BUILDING SCOPE ADDENDUM NO. 01

This Addendum is a summary of clarifications, interpretations, corrections and/or modifications to the Contract Documents for the Conestoga High School Athletic Fields Project prepared by Heckendorn Shiles Architects.

1 PLUMBING - FIELD HOUSE DOMESTIC WATER PIPING PLAN
P101 1/8" = 1'-0"

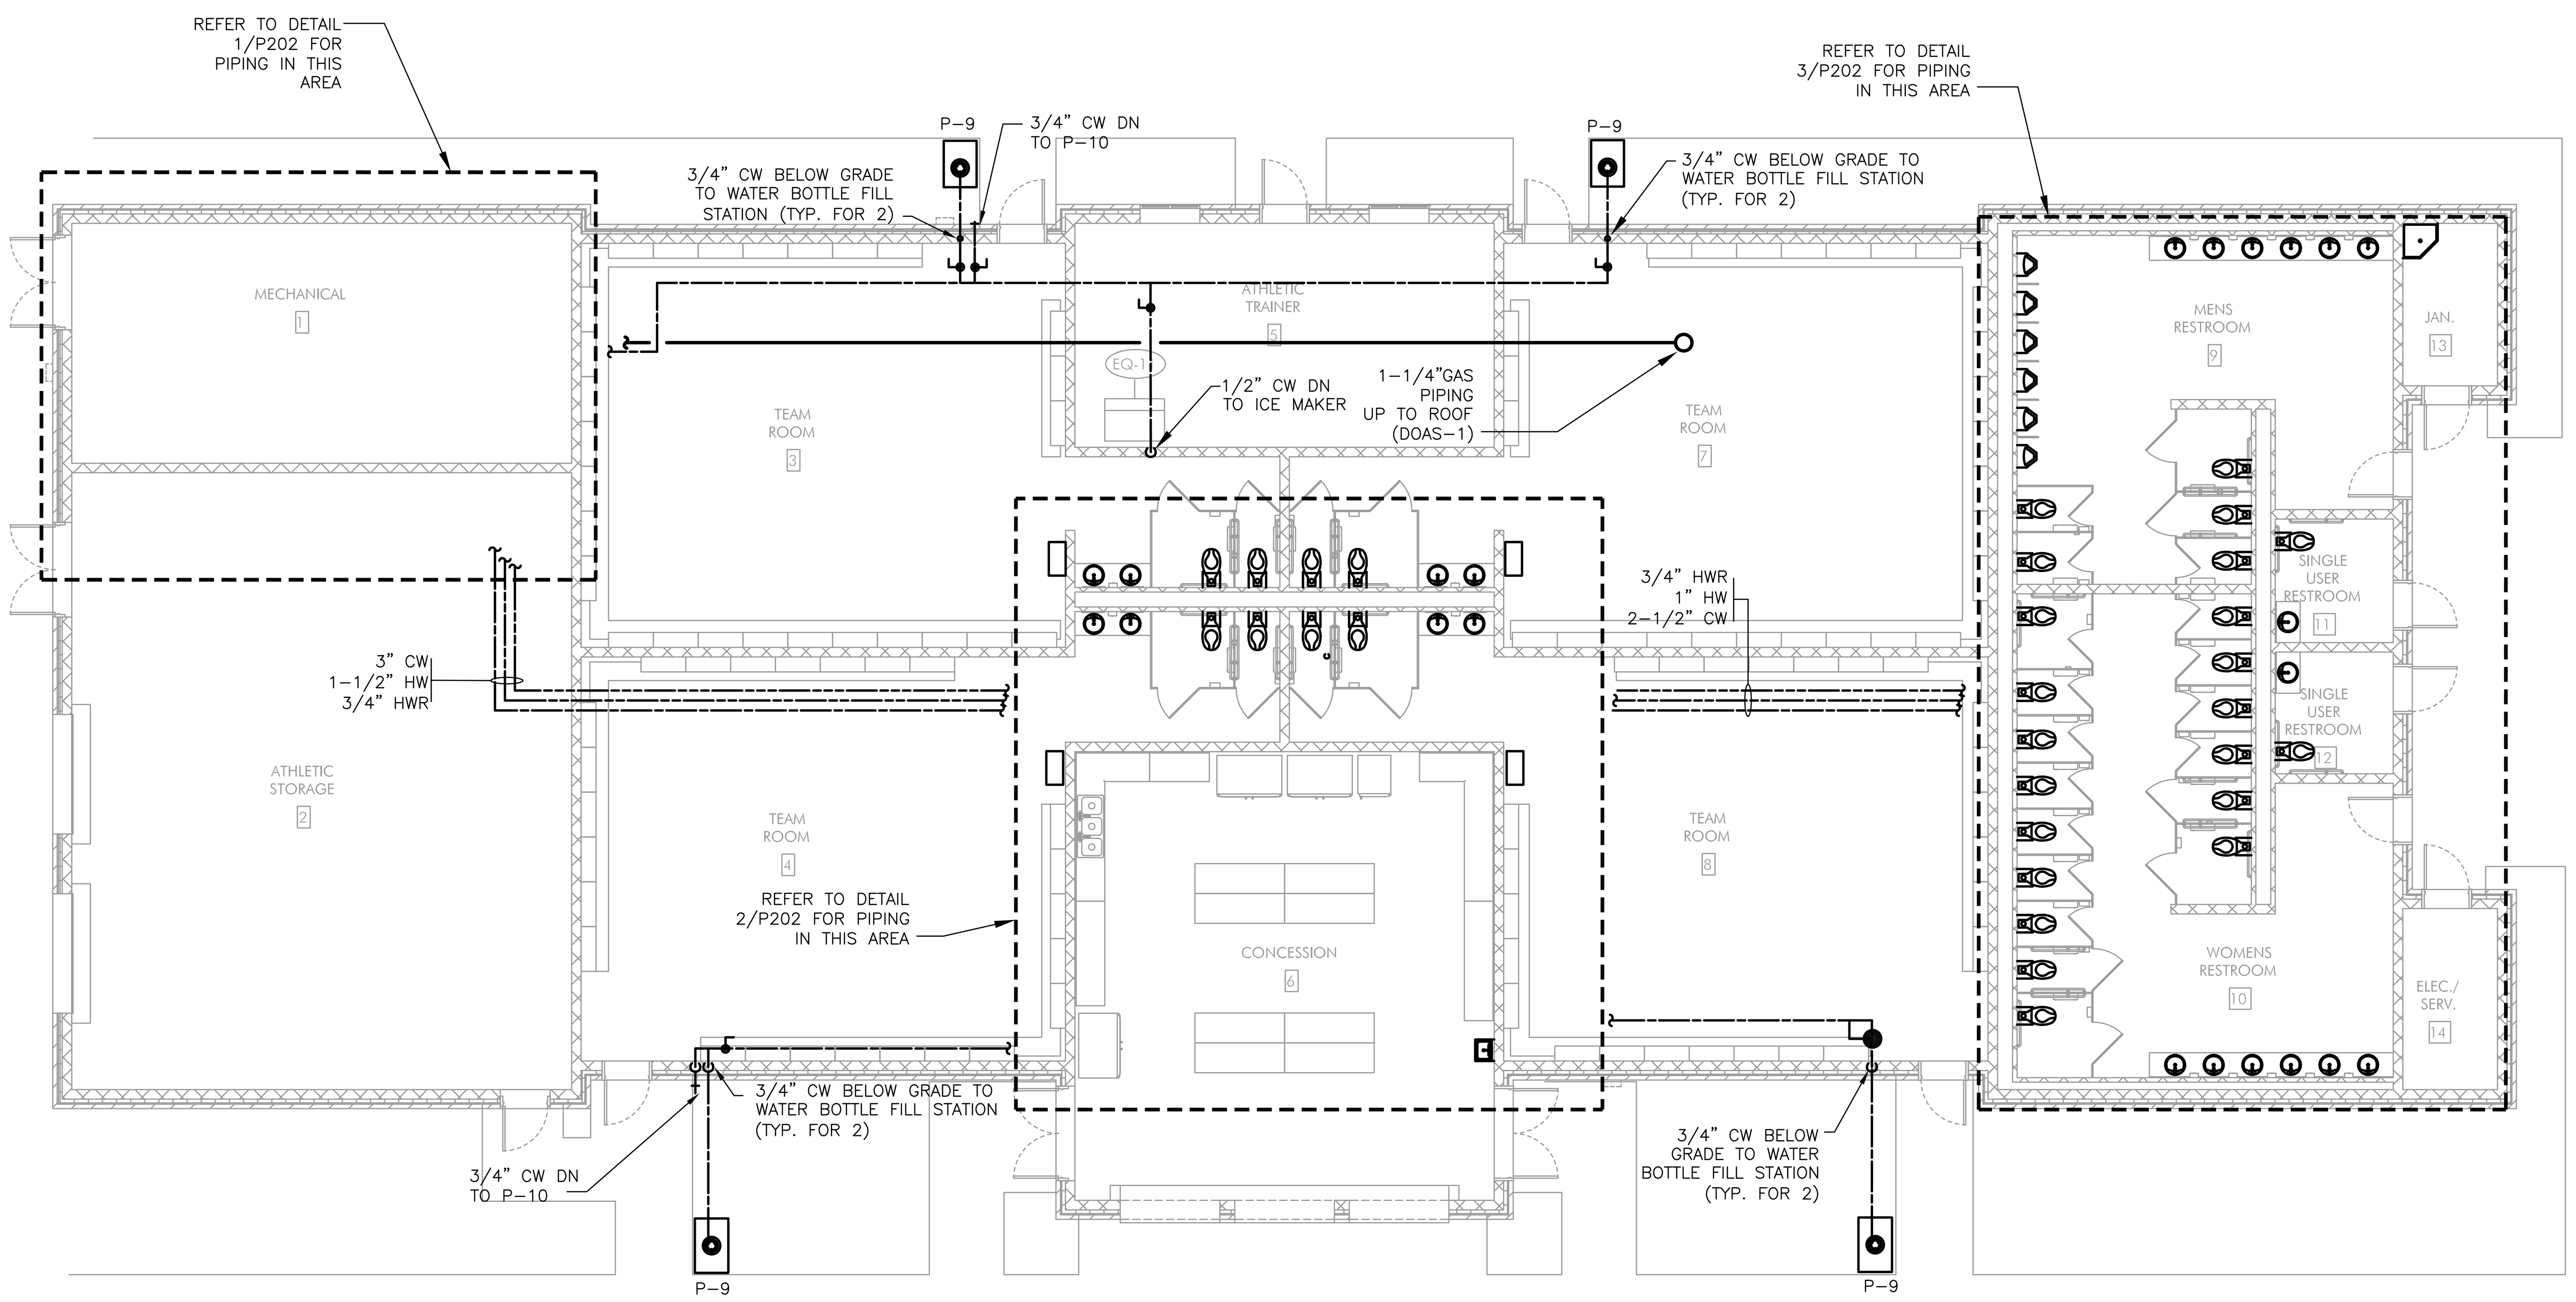
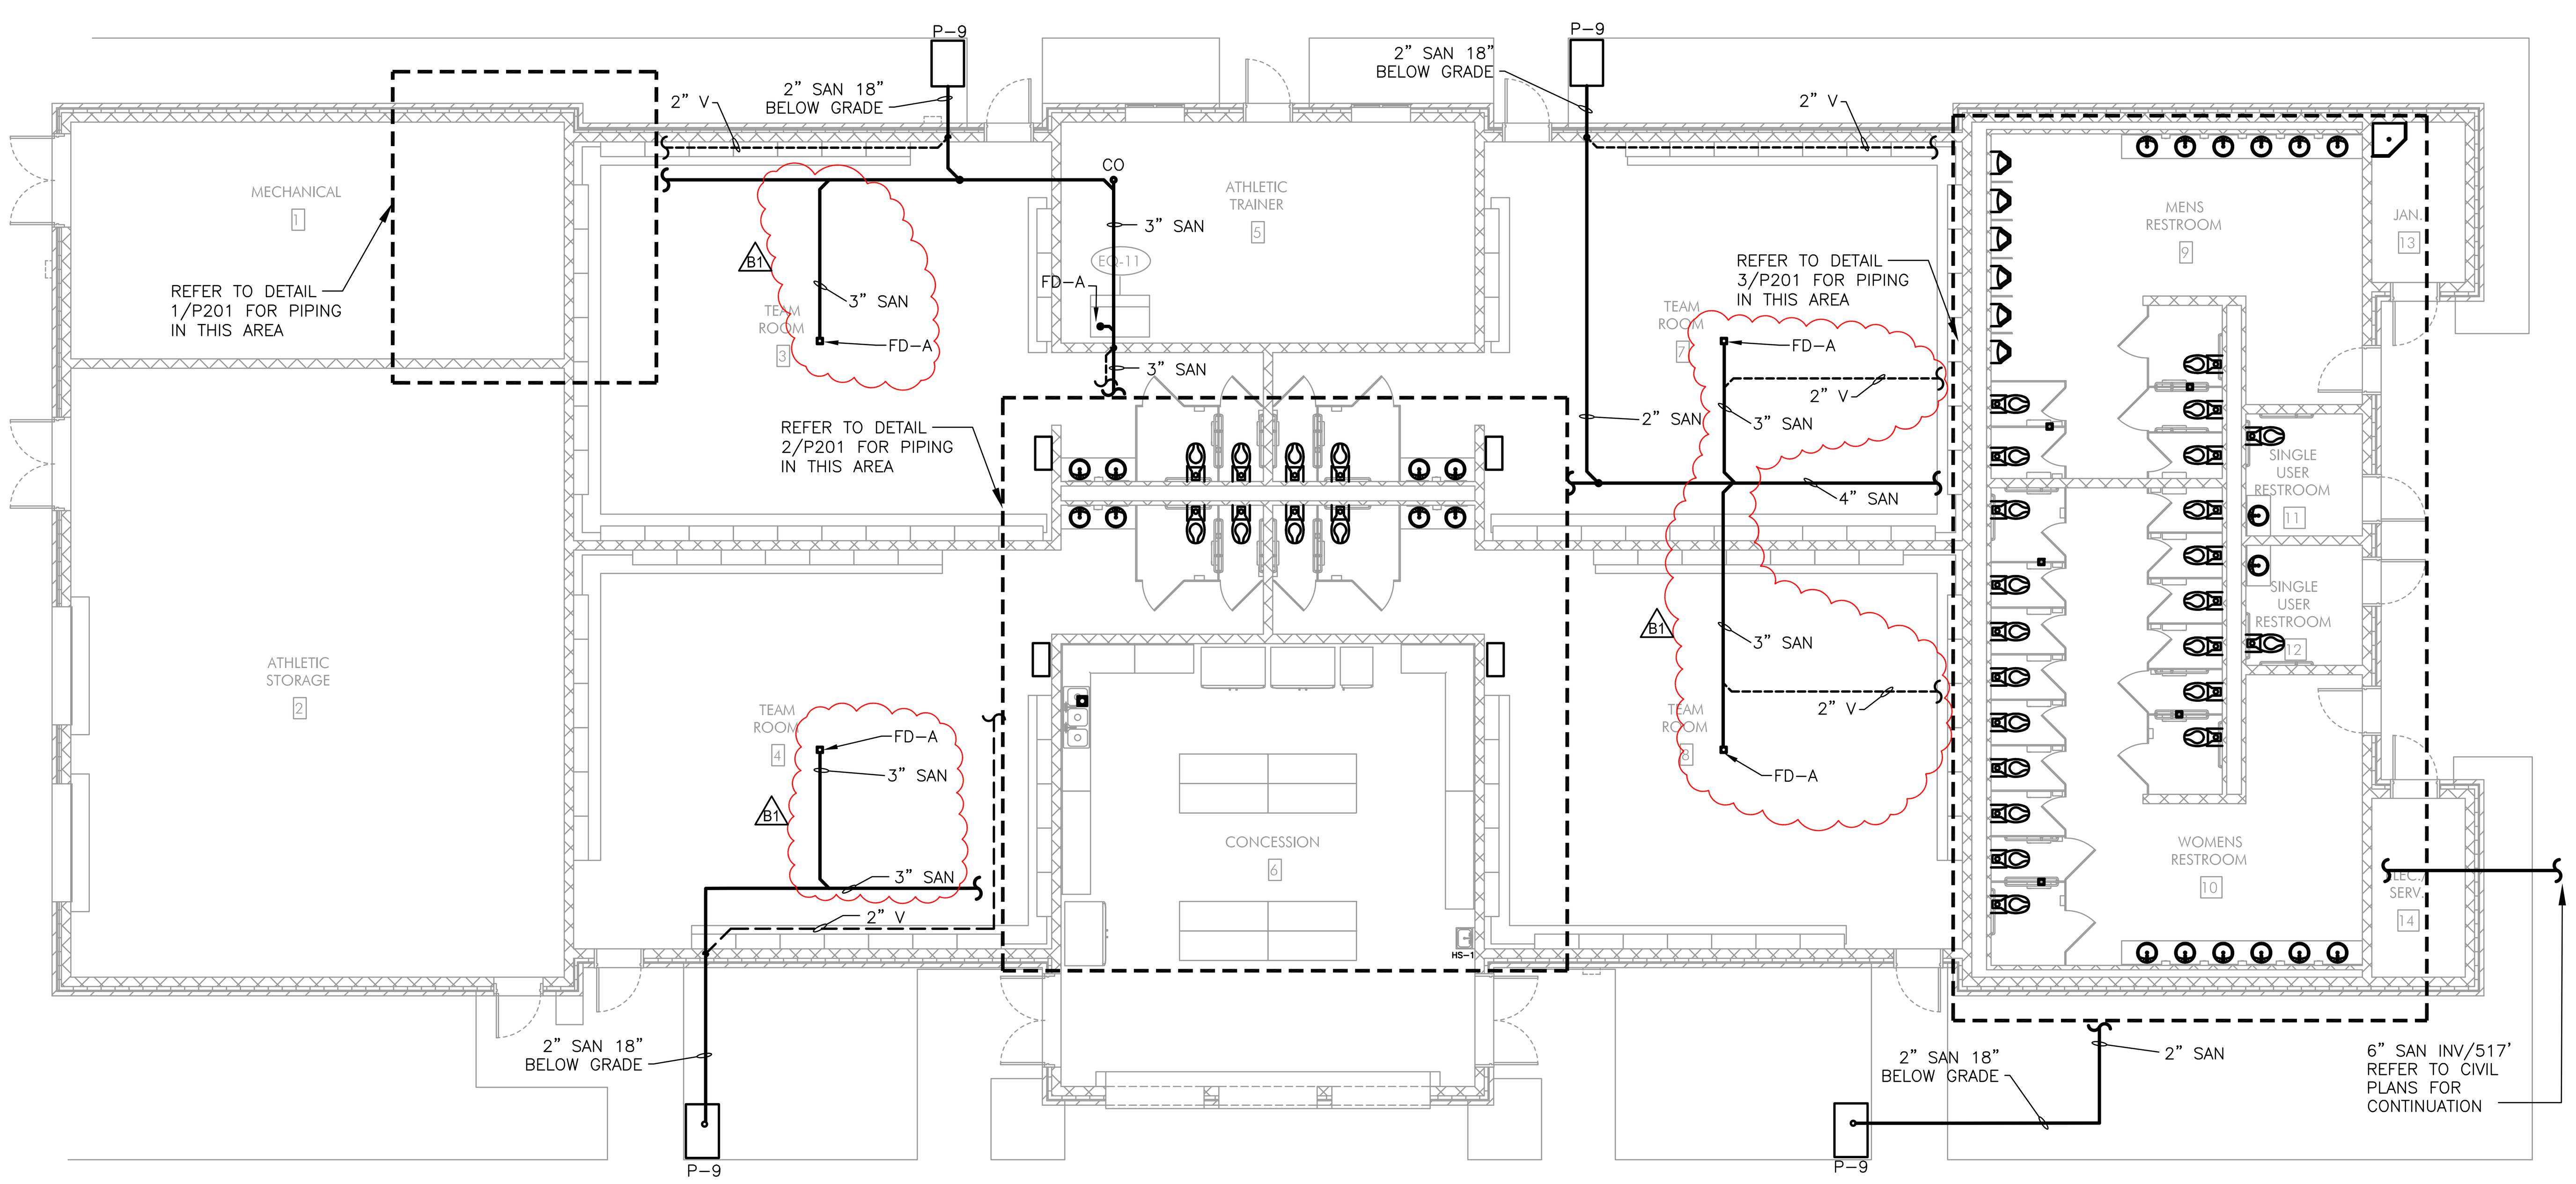
1. Specification – 221319 Sanitary Waste Piping Specialties – Added Section
2. Drawing – P001 Updated drawing list
3. Drawing – PS01 Updating scope of work between contractors.
4. Drawing – P101 Added floor drains
5. Drawing – P301 Changed model number for fixure P-2
6. Drawing – P401 Modified NG riser diagram to show scope of work between contractors.
7. Drawing – P402 Modified note on San riser diagram and added floor drains. Updated floor drain nomenclature to match floor plans.
